(Engineering comments by Jeff Rice)

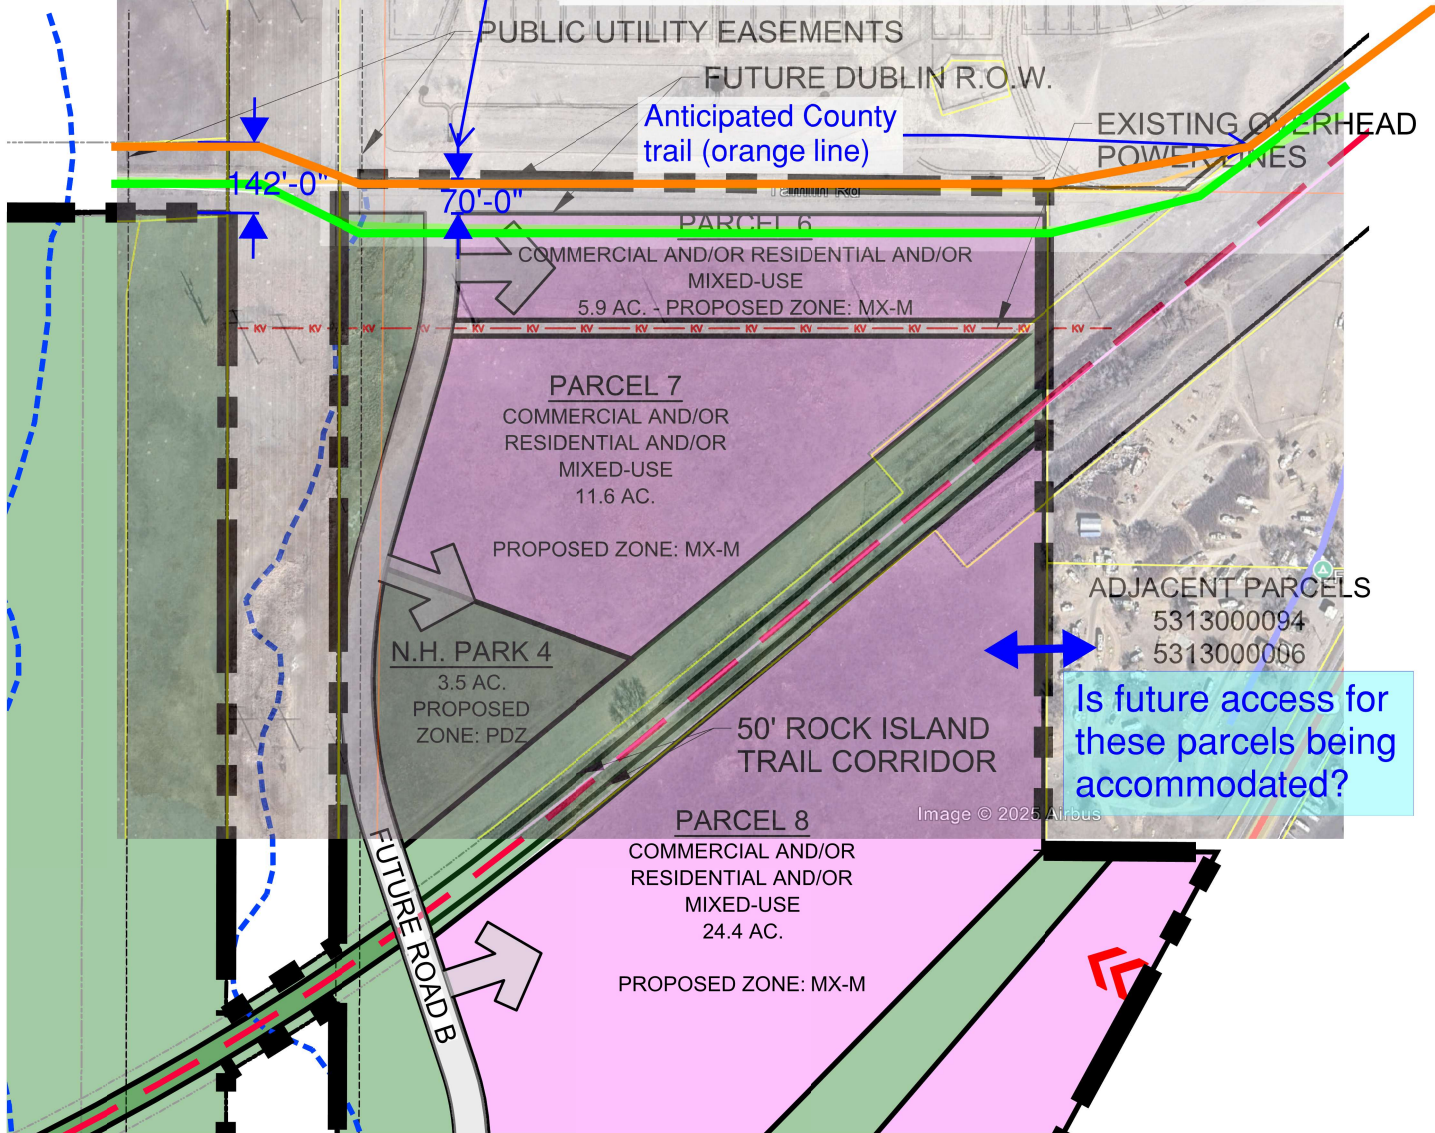
Why is ROW half of what is needed? (If Dublin is proposed to be split between incorporated and unincorporated areas, property acquisition from Falcon Highlands and EPC will be needed and County trail alignment (Rock Island and Falcon Hwy routes) in Tamlin Road ROW will need to be addressed.) (There was some coordination with Tim Roberts at the City in July 2022.)
